**Notice of Compliance with Conditions and Construction Completion**

**Subject: Post Construction Inspection Report**

**T-Mobile Designation:**                      **Site Number:**                      CT11372B  
**Site Name:**                                      SBA N Branford East

**Site Data:**                                      **39 Ciro Road, North Branford, New Haven County, CT 06471**  
**Latitude 41° 19' 51.82", Longitude -72° 45' 22.22"**  
**170 Foot – Monopole Tower**

**A-2**

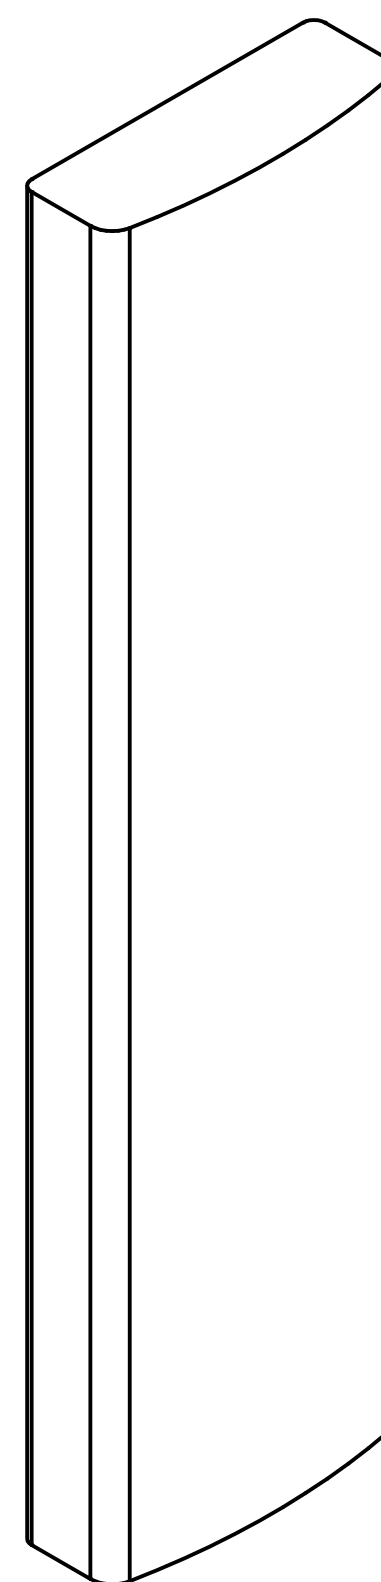
Photograph	Observations and Recommendations
	<p><b><u>Item 1:</u></b></p> <p><b>Observation:</b> As-built antenna and radio configuration does not match the layout as shown in the construction drawings. The antennas and radios to be installed in position 4 was installed in position 1 and position 4 was left empty on all sectors.</p> <p><b>Recommendation:</b> No action required. GC redlined these changes on the construction drawings. See Appendix A.</p>

Photograph	Observations and Recommendations
	<p><b>Item 2:</b></p> <p><b>Observation:</b> Construction drawings show an empty mount pipe installed on position 1. An empty mount pipe was not installed on the mount on all sectors.</p> <p><b>Recommendation:</b> No action required. GC redlined this change on the construction drawings. See Appendix A.</p>

\*No existing empty  
 pipe mount (all  
 sectors)\*

**\*RFS  
APXVAALL24\_43-U-NA20  
INSTALLED ON POSITION 1  
IN EACH SECTOR\***
